## MODELS **3120, 2101**

### CLUTCH

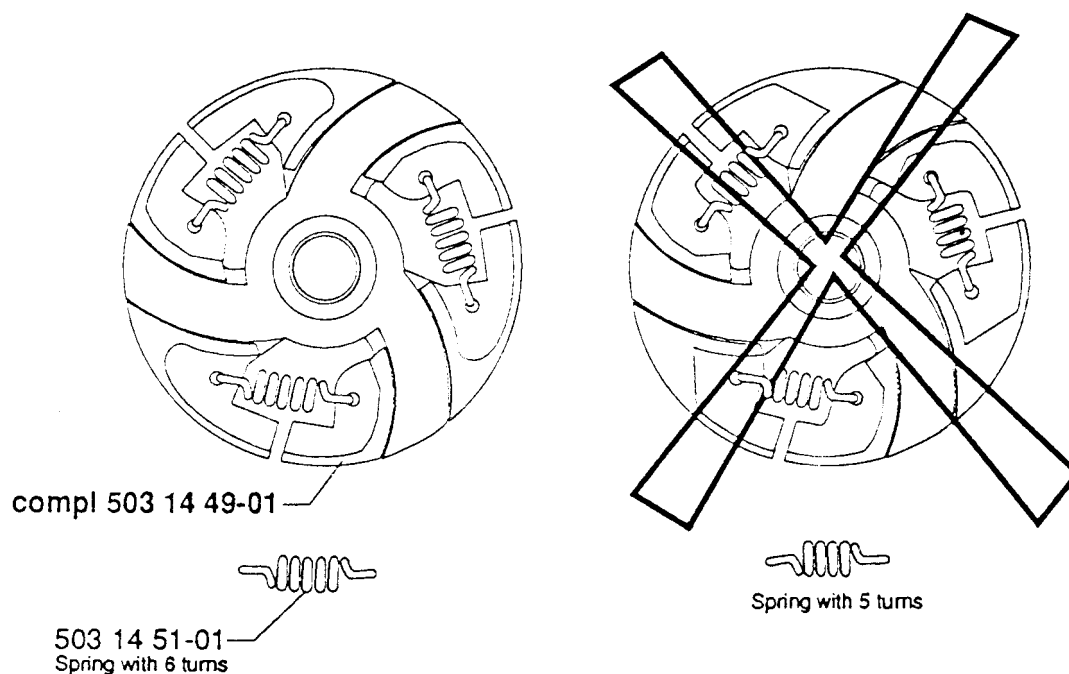
We have added one turn on the spring in order to even more improve the durability on the clutch springs.

- Changed clutch shoes (moved holes)
- Longer springs (now 6 turns previous 5)

NOTE! The clutch springs are not interchangeable.

New Ref. No.	Description	Excluded Ref. No.	Remark
503 14 49-01	Clutch compl.	503 13 38-01	
503 14 51-01	Clutch spring		
	Clutch spring, white	503 13 42-01	remains as spare parts for previous design
